ANSI/ASHRAE/IESNA Addenda a, b, c, g, h, i, j, k, l,
m, n, p, q, s, t, u, w, y, ad, and aw to
ANSI/ASHRAE/IESNA Standard 90.1-2007

2008 SUPPLEMENT

Energy Standard for Buildings Except Low-Rise Residential Buildings

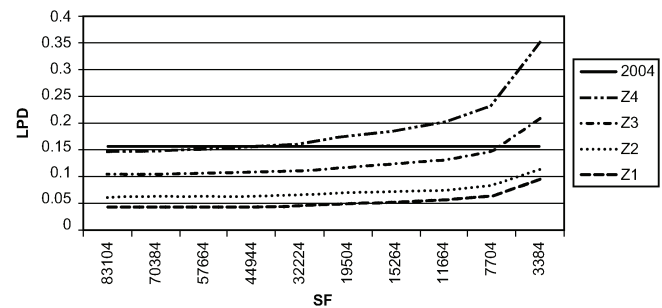
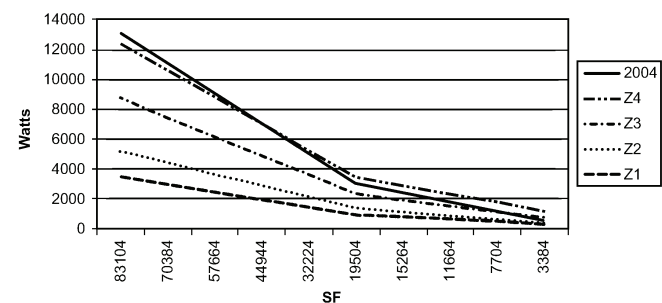
This proposal will apply a four-zone lighting power density approach to exterior lighting requirements. This approach recognizes the varying lighting needs and design differences associated with different building locations. It is acceptable and prudent to reduce the light levels as the designer leaves the downtown city center entering into mixed commercial/high-rise residential districts, then enters into residential areas, and then into rural areas. Several organizations, including the IESNA have been working to develop a zonal approach to exterior lighting recommended practice and this change in the standard will follow that guidance.

The first change in Section 9.4.5 is the deletion of the 5% additional power allowances, which is replaced by a base wattage allowance per site. The second change to this section is to define the four zones and apply appropriate requirements. The four zones are based on IESNA and other group definitions to match other requirements and guidance expected to be encountered by designers. The majority of building sites will fall into LZ3, LZ2, or LZ1, and the sites that remain in LZ4 will generally be of relatively small sizes. The added “Base Site Allowance” for each zone takes into account that most sites are not rectangular or match the iso-diagram of typical light luminaires.

was used to determine appropriate base site allowances. Because of the base site allowance, the actual LPDs are on a sliding scale, as shown below.
